Architectural Review Board Report

Architectural Review Board Meeting: April 6, 2015

Subject: Bifurcated approval of the design, materials, and colors of new accessory structures pursuant to Condition No. 3 of 14ARB-358 and modifications to previously approved landscape plans and sign program for an existing office complex, The Water Garden.

Addresses: 1620 26th Street
2425 Olympic Boulevard
2450 Colorado Avenue
1601 Cloverfield Boulevard

Figure 1, Revised Pavilion Rendering

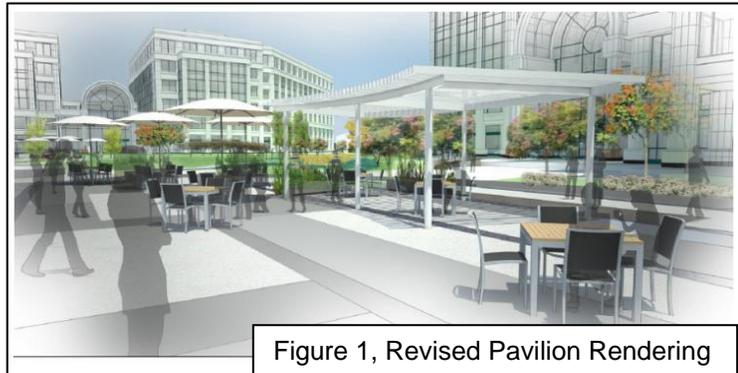
During the ARB's most recent review of the pavilion, board members further encouraged the applicant to re-examine the design approach and elaborate on the architectural relationship between the trellis and pavilion elements. In response, the applicant revised the pavilions to be more in character with the trellis elements on Colorado

Avenue by simplifying the material selection and creating an arrangement that echoes the geometry of the Central Plaza. The two pavilions are composed of architecturally exposed structural steel with a warm white finish (See Figure 1) and aesthetically correlated to the trellis structures in the motor court area of the office park.

Figure 2, Revised Trellis Rendering

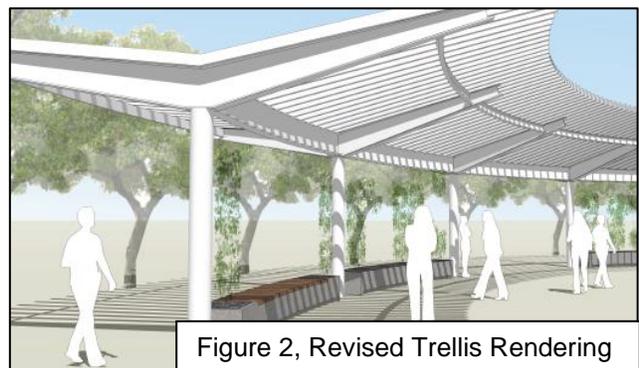
In response to the ARB's comments, the applicant revised the trellis elements to incorporate additional shading and planting opportunities to the design. The density of the overhead trellis members increased from 1 member at 4 degrees to 1 member at 1.5 degrees. The profile of the trellis members are changed from 3"x 3" to 2"x 6" for a more pronounced curve and dimension that is

is consistent with the with the member sizes from the pavilion structures. Two planter benches and two additional planters are added at each trellis (See Figure 2) for an enhanced automobile pick-up and drop-off experience.
